Addressing Opinions/Questions/Inputs from Meeting #11

Author: Yair Darshan

Date August 15, 2014

Contribution for 802.3bt End to End Channel Pair to Pair Resistance Unbalance Adhoc.

The maximum pair current with the lowest resistance equation

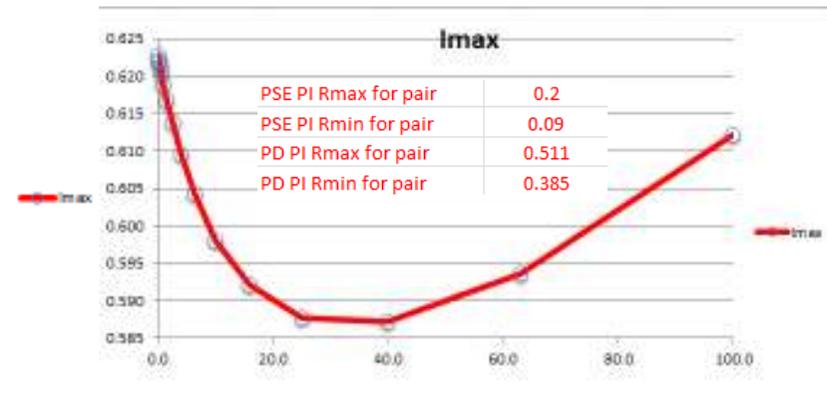
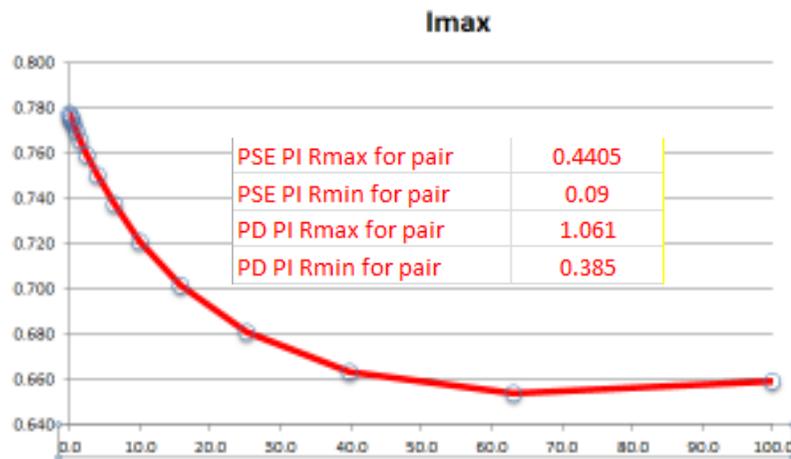
- Using adhoc database values for components. Annex G1.
- The high C_P2PRUNB at short cable is dominating by PSE PI and PD PI components.
- PSE and PD PI affect also the system unbalance at 100m.
- We can see that if Channel P2PRUNB=5.5% or 7.5% at 100m YOU will not notice the differences!
- The End to End Channel P2PRUNB was simulated at 51W load. Confirmed with PSPICE and MATLAB and Excel tools. (Differences of < between tools results negligible for the purpose of drawing conclusions and mainly are results of diode model approximation used with MATLAB and Excel).

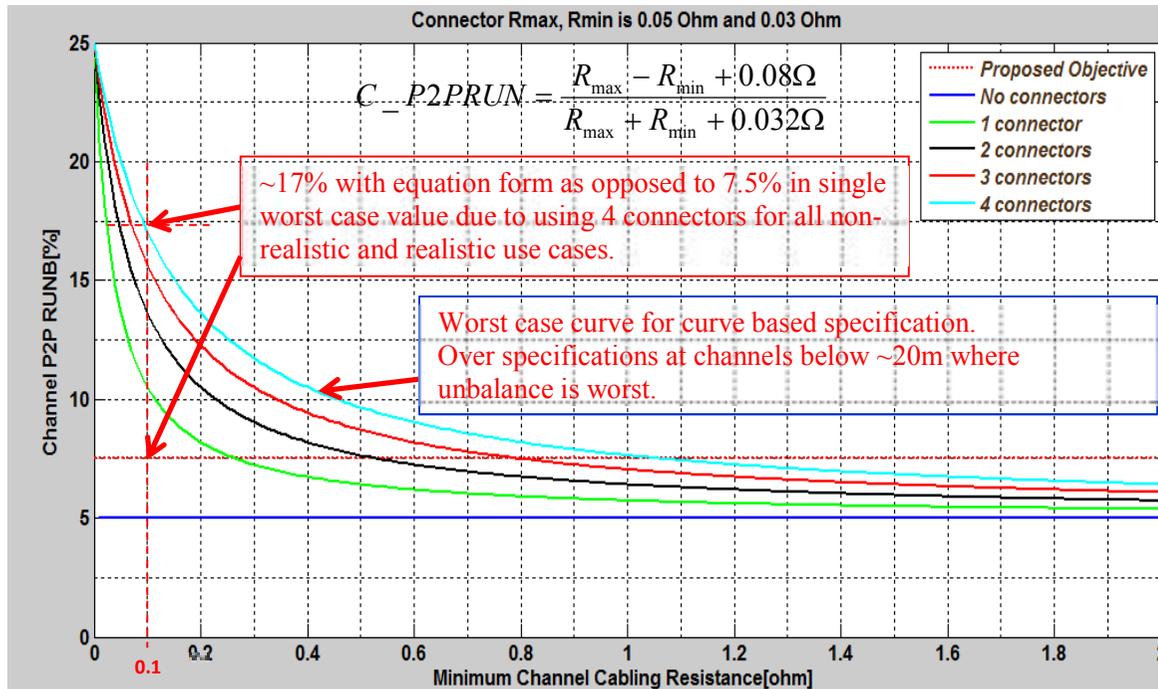
- AT 100m, The 2% margin will be overtaken by the PSE PI and PD PI which are >>5.5% (10-20% at system level pending PSE/PD PI components).
- It is easy to quick calculate it:
- The system has 15% unbalance at 100m. The current is per simulation 659mA.
- The Channel unbalance at 100m increases from 5.5% to 7.5%=2%.
- The current in system level was increased to just 668mA. **This is only 9mA** at 51W.
 - 14mA at 80W.
- Only 1.4% increase in pair current due to 2% margin in the channel level.

(Higher effects as claimed at adhoc meeting #11 was due to error in the commenter’s model and calculations as expected.

The source of the error is that the commenter use only channel in the system level for calculating the pair current without accounting for PSE and PD PI. It will be also incorrect if it will be argued in the future that there is a PSE or PD that has unbalance qualities similar to the channel i.e. 5.5%. This is not practical. PSE PI and PD PIs have connector and transformers and other components that has >>5% unbalance. See adhoc database for details.
